**PRODUCT
SUPPORT
BULLETIN # 488**

TOOL(S) \ PRODUCT(S) AFFECTED: 1001-1, 1007-1, 1107-1, 1250-1 D-Handle Drill 6509-20, 6509-22, 6519-22, 6520-21, 6523-21, 6536-21, 6523-55 Orbital Sawzall & 6538-21 Orbital Super Sawzall

SUBJECT: Service Note: 23-66-0205, 23-66-2490 Switch proper removal or installation of the switch remote dial / electronic assembly terminal/lead(s)

**23-66-0205 Switch
single terminal
remote dial assembly connection**

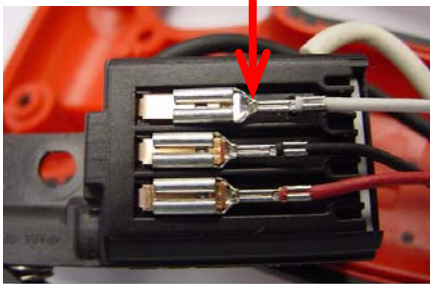
lead wire / female terminal laid flat in channel

proper assembly of the female Remote Dial Assembly or Remote Electronic Assembly lead wire(s) terminal to the 23-66-0205 / 23-66-2490 Switch should be done by...

first, laying the female terminal(s) – lead wire assembly(ies) into the channel of the switch – **lifting of brass switch terminal should be kept at a minimum**

then, utilizing the tip of a flat blade screwdriver to 'push' and fully seat the lead wire female terminal onto the male brass switch terminal.
